Subject: 10 CFR Part 21 Report – Inconsistent crimping of motor leads to ring terminal connectors and Failure to Comply. Trillium Valves USA Part 21 Evaluation I211003

LIMDOC-2022-004

**Subject: Inspection of terminal samples returned from Trillium Valve**

**Photo # 1: Five Terminals Removed from Actuator**

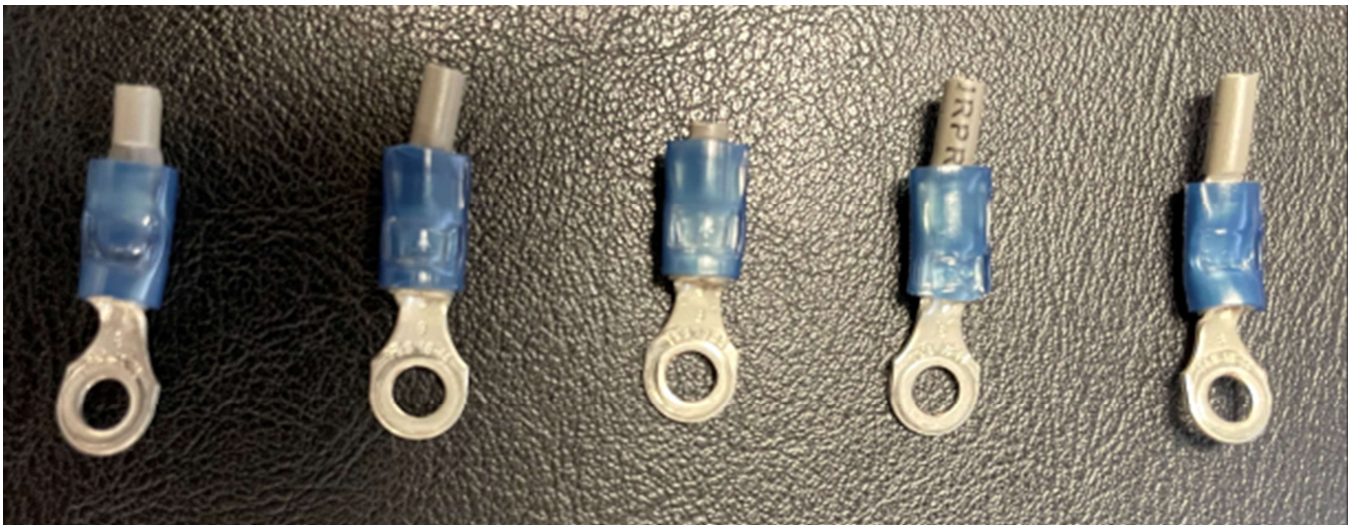
Photo # 1 provided by Trillium Valve shows five ring tongue terminal connectors removed from the actuator identified as serial #L983445. Two of these terminals were returned to Limitorque from Trillium Valve. The returned samples, designated as RS1 and RS2 are shown in photos # 2 & 3. The terminals were forwarded to the engineering special test lab for evaluation. For comparison purposes, Flowserve QA also provided the lab with three samples of terminal connectors that were installed and crimped by the Lynchburg production wiring department. These are shown in photo #4.

The three comparison samples shown in photo #5 are uniform in appearance. In contrast, the terminal connectors shown in photos #1, 2, 3, & 4 show inconsistencies in the location of the crimp and the extent of deformation of the barrel and insulator.

Limitorque's inspection has determined that the root cause of the intermittent continuity at the wire conductor to terminal connection is likely attributable to a workmanship error resulting in inconsistent crimping of the lead wire to the terminal. On sample RS2, the conductor was not fully inserted into the terminal barrel prior to crimping. On samples RS1 & RS2, the crimping tool was not positioned properly on the terminal barrel prior to the crimp. The other terminals shown in photos 1 & 2 exhibit similar inconsistencies.

**Photo # 3: Samples Returned for Evaluation**

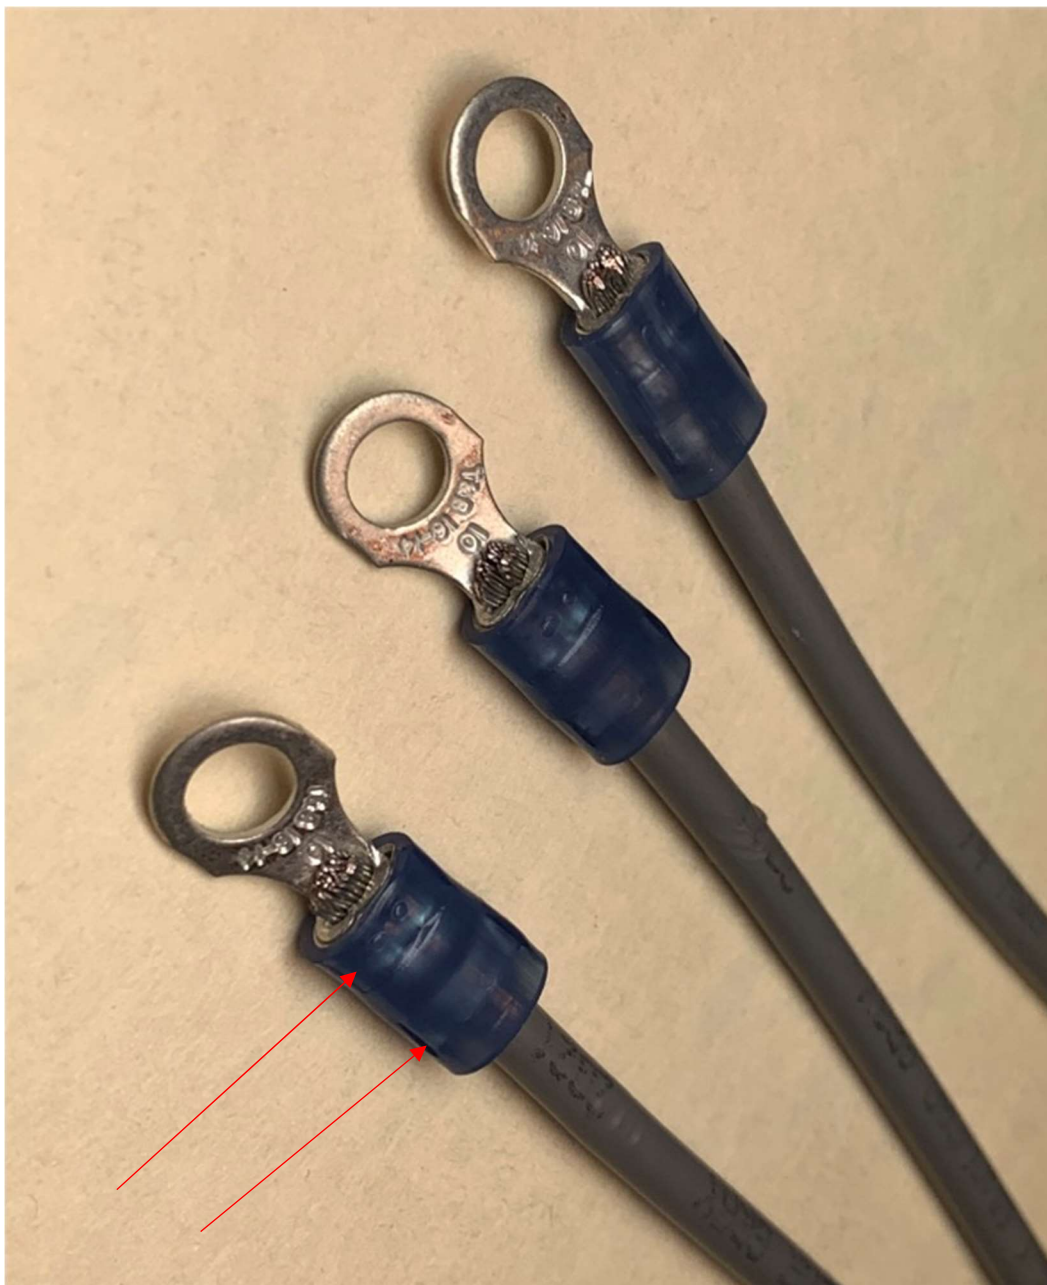
- Terminal RS1, identified as the terminal with the longest wire protruding, showed no continuity initially but when the end of the wire was manipulated continuity was intermittent. The wire appears to have been partially pulled out of the connector evident by the crimp impression in the wire insulation below the terminal and, also evident by the wire conductor not extending to the end of the barrel on the terminal side. Also, the wire did not appear to be firmly held when the wire was manipulated for the continuity test. The wire conductor was approximately 0.045" short of reaching the end of the terminal barrel.

- Terminal RS2, identified as the terminal with the short wire protruding, initially checked good continuity however manipulation of the wire caused continuity to drop on at least one occasion. The wire appears to be still firmly held by the crimp however there is very little wire protruding from the terminal to make this evaluation. The wire conductor was approximately flush with the end of the terminal barrel.

RS1: Secondary crimp partially on the wire insulation rather than the terminal insulator

RS2: Primary crimp not positioned correctly over the barrel of the terminal housing the conductor

**Photo # 6: Crimping Tool**

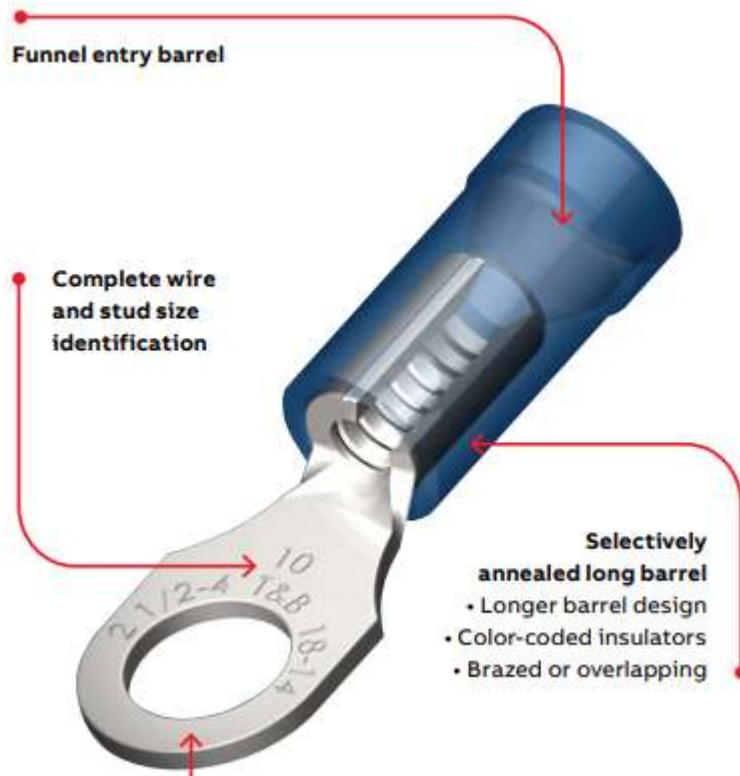
The crimping tool used by Limitorque (reference photo # 6) has jaws that crimps the connector in two places simultaneously. The primary crimp compresses the serrated barrel (reference Figure 1 and Photo #7) onto the wire conductor. The secondary crimp compresses the funnel entry barrel onto the outer wire insulation.
